Access Compliance Report

Public Rights-of-Way

Intersection ID: 30507	Main Street: GOLDEN_SUN_CT	Cross Street: PLANTERS_ESTATES_DR	Location: SE
ADA ID: EC71413AE17C	Ramp Type: PerpDiag	Initial Pass/Fail: Fail	Overall Compliance: No
Severity Score: 8.75			
Codes/Mitigation Info/Possible Solution		Field Measurements/Component Compliance

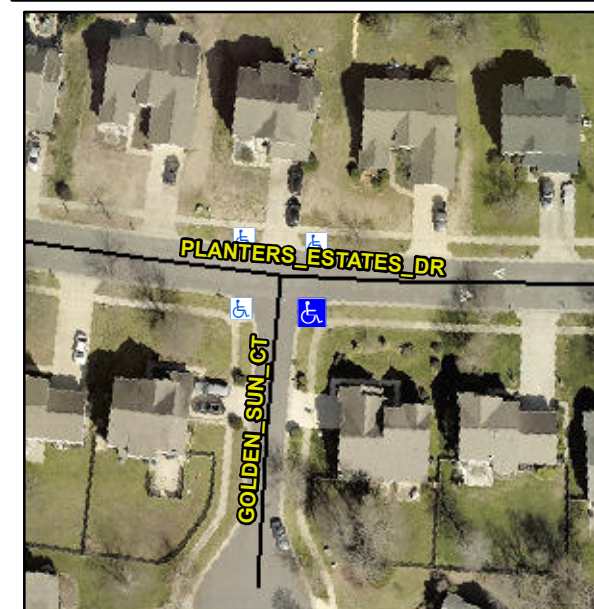
Not Found, R304.5.1

Compliance	Description	Data	Compliance	Description	Data
N/A	Ramp Length (in)	87.0	Yes	Ramp Slope (%)	6.9
No	Ramp Width (in)	36.5	Yes	Ramp XSlope (%)	0.2
N/A	Flare Type LT	N/A	N/A	Flare Type RT	N/A
N/A	Flare Slope LT (%)	N/A	N/A	Flare Slope RT (%)	N/A
N/A	Flare Traversable LT?	N/A	N/A	Flare Traversable RT?	N/A
N/A	Landing Length (in)	N/A	N/A	DWS Provided?	N/A
N/A	Landing Width (in)	N/A	N/A	DWS Contrast?	N/A
N/A	Landing Slope (%)	N/A	N/A	DWS Length (in)	N/A
N/A	Landing X Slope (%)	N/A	N/A	DWS Full Width?	N/A
N/A	Landing Curb? (Y/N)	N/A	N/A	DWS Offset (in)	N/A
N/A	Shared Landing?	N/A			
N/A	Gutter Ponding?	N/A	N/A	Gutter Slope (%)	N/A
N/A	Gutter Lip Ht (in)	N/A	N/A	Gutter X Slope (%)	N/A
N/A	Painted X Walk1?	No	N/A	Painted X Walk2?	No
	X Walk 1 Direction	To NE		X Walk 2 Direction	To NW
N/A	X Walk 1 Width (in)	N/A	N/A	X Walk 2 Width (in)	N/A
	X Walk 1 Slope (%)	1.4		X Walk 2 Slope (%)	1.0
	X Walk 1 X Slope (%)	0.7		X Walk 2 X Slope (%)	1.2

Remove & Replace Curb Ramp With Two New Directional Ramps or Equivalent.
